802.3dj D2.1 Comment Resolution Electrical Track

Adee Ran (Cisco), 802.3dj Electrical Track Lead Editor Matt Brown (Alphawave Semi), 802.3dj Chief Editor Howard Heck (TE Connectivity)

- This slide package was assembled by the 802.3dj editorial team to provide background and detailed resolutions to aid in comment resolution.
- Specifically, these slides are for the various electrical-track comments.

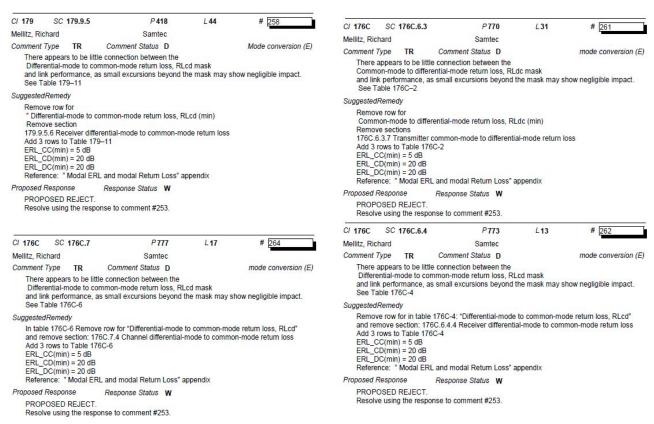
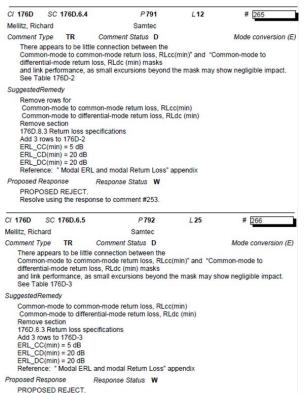
C/ 178 SC 178.9.3 P380 L13 Mellitz, Richard Samtec Comment Type TR Comment Status D mode conversion (E) There appears to be little connection between the Differential-mode to common-mode return loss, RLcd mask and link performance, as small excursions beyond the mask may show negligible impact. See Table 178-9 SuggestedRemedy Remove row for "Differential-mode to common-mode return loss, RLcd" and remove section: 178 9 3 7 Receiver differential-mode to common-mode return loss Add 3 rows to Table 178-9 ERL CC(min) = 5 dB ERL CD(min) = 20 dB ERL_DC(min) = 20 dB Reference: "Modal ERL and modal Return Loss" appendix Proposed Response Response Status W PROPOSED REJECT. Resolve using the response to comment #253.

SC 178.10 CI 178 P384 L40 Mellitz, Richard Samtec Comment Type TR Comment Status D mode conversion (E) There appears to be little connection between the Differential-mode to common-mode return loss, RLcd mask and link performance, as small excursions beyond the mask may show negligible impact. See Table 178-11 SuggestedRemedy Remove row for "Differential-mode to common-mode return loss, RLcd" and remove section: 178 10.5 Channel mode conversion insertion loss Add 3 rows to Table 178-9 ERL CC(min) = 5 dB ERL CD(min) = 20 dB ERL DC(min) = 20 dB Reference: "Modal ERL and modal Return Loss" appendix Proposed Response Response Status W PROPOSED REJECT. Resolve using the response to comment #253. C/ 179 SC 179.9.4 P408 L31 Mellitz, Richard Samtec Comment Type Comment Status D Mode conversion (E) There appears to be little connection between the Common-mode to common-mode return loss, RLcc(min)" and "Common-mode to differential-mode return loss, RLdc (min) masks and link performance, as small excursions beyond the mask may show negligible impact. See Table 179-7 SuggestedRemedy Remove rows for Common-mode to common-mode return loss. RLcc(min) Common-mode to differential-mode return loss, RLdc (min) Remove sections 179.9.4.8 Common-mode to common-mode return loss 179.9.4.9 Common-mode to differential-mode return loss Add 3 rows to Table 179-7 ERL CC(min) = 5 dB ERL CD(min) = 20 dB ERL DC(min) = 20 dB Reference: "Modal ERL and modal Return Loss" appendix Proposed Response Response Status W PROPOSED REJECT Resolve using the response to comment #253.

Editors' recommendation for 253-254, 256-259, 261-262, and 264-268: REJECT.

- There are numerous comments suggesting adding a set of "modal ERL" specifications in multiple places in the draft.
- The suggested specifications were mentioned in <u>mellitz 3dj adhoc 01a 250828</u>, but a proposal for their definitions was not included.
- It as not been demonstrated that the values suggested in the comments are appropriate (feasible and correlated with system performance).
- The suggested remedy does not provide sufficient detail to implement.

Proposed text and new figure

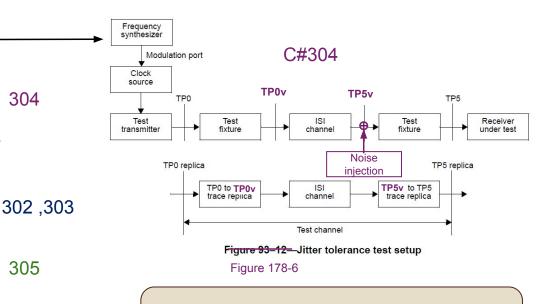
CI 178 SC 178.9.3.5 P383 L 10 Healey, Adam Broadcom Inc. Comment Type TR Comment Status D Figure 93-12 does not include broadband noise injection and therefore does not represent the specified jitter tolerance test setup. It is unclear why there are references to Annex 93A, 93C, and 120D. SuggestedRemedy Add a new figure to 178.9.3.5 that illustrates a test setup with both litter and noise injection. Replace the second sentence of the first paragraph of 178.9.3.5 with a reference to this Proposed Response Response Status W PROPOSED ACCEPT IN PRINCIPLE. Implement the suggested remedy with editorial license. CI 178 SC 178 9 3 5 P383 L14 Healey, Adam Broadcom, Inc. Comment Type Comment Status D JTOL (E) 178.9.3.4.1, which is incorporated into this test procedure by reference, states that the "transmitter meets the requirements stated in 178.9.2...". It should be made clear that the

CI 178 SC 178.9.3.5 P383 Ran Adee Cisco Systems Comment Type TR Comment Status D JTOL (E) "Case F" used for jitter was intended to be the highest frequency case, should have been changed to case G when we added an extra case Also in 176C.6.4.6. SuggestedRemedy Change "Case F" to "Case G" in both subclauses. Change the phrasing is necessary with editorial license Proposed Response Response Status W PROPOSED ACCEPT IN PRINCIPLE Resolve using the response to comment #303

Cl 178 SC 178.9.3.5 P383 L17 # \$85 Ran, Adee Cisco Systems Comment Type E Comment Status D JTOL (E) The dashed list format should be: — The test channel COM <...> — For the COM parameter calibration described in 93C.2 item 7): (same level) [2nd level] — Additive noise is calibrated with jitter specified in case G from Table 179-13. [2nd level] — Both JRMS and J4U03 are measured with the additive noise and the jitter of

(\$\frac{1}{28}\$\frac{1}{6}\$) itter tolerance is verified for each pair of jitter frequency and peak-to-peak amplitude values listed in Table 179–13. The test setup shown in Figure 93–12 178-6, or its equivalent, is used. TP0v (TP5v) replaces TP0a (TP5a) in Figure 93-12, Annex 93A, Annex 93C, and Annex 120D. The test channel meets the insertion loss requirement for Test 2 in Table 178–10. The synthesizer frequency is set to the specified jitter frequency and the synthesizer output amplitude is adjusted until the specified peak-to-peak jitter amplitude for that frequency is measured at TP0v. The test procedure is the same as the one described in 178.9.3.4, with the following exceptions: The test procedure is the same as the one described in 178.9.3.4 with the exception that transmitter output is measured with the jitter frequency and amplitude set according to Case G from Table 179–13. The transmitter meets the requirements in 178.9.3.4.1 with the added jitter from Table 179-13 included

Editorial team recommendation: ACCEPT IN PRINCIPLE. Implement the changes on this slide with editorial license...

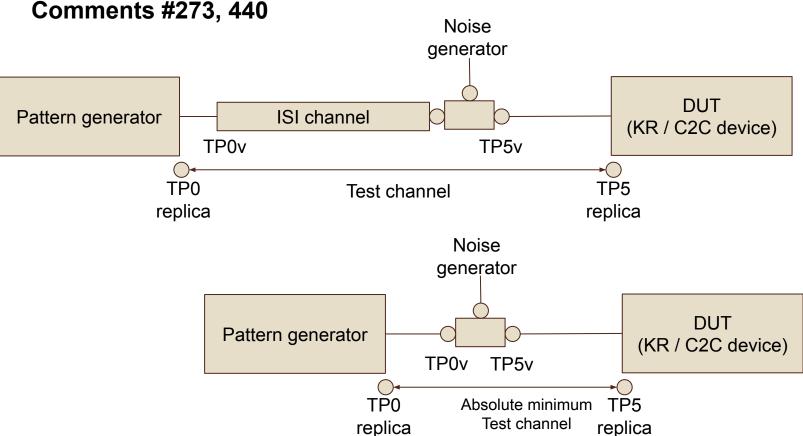
C/ 176C SC 176C.6.4.2 P773 L 28 # 440 Dudek, Mike Marvell Comment Type Comment Status D RX test channel IL (E)

This comment is related to unsatisfied comment #535 to D2.0. Inserting the the minimum channel loss from the KR interference tolerance test (14.5dB) between the Tx and Rx does not adequately test the overload for C2C where much lower minimum losses are expected. (The minimum loss is presently not specified for C2C. Assuming that the pattern generator used in the overload test has a similar loss to a minimum loss real package the loss should be equal to the minimum loss in the C2C link. 2dB allowing for a minimum trace length of approx 2 inches with low loss materials seems reasonable.

Change "using a channel with the minimum insertion loss specified in 178.9.3.4" to "using a channel with the recommended minimum insertion loss specified in 176C.7.2. Add another paragraph to 176C.7.2. "The recommended minimum insertion loss for the channel between TP0 and TP5 is 2dB."

Align the minimum channel loss with that used for RX ITOL testing (9.5 dB - 10.5 dB) by changing the reference in the first paragraph of from 178.9.3.4 to Table 176C-5.

Both comments address the minimum IL test channel - for "Test 1" in ITOL, and for ATOL. They suggest somewhat different numbers: 15 dB vs. 2 dB.
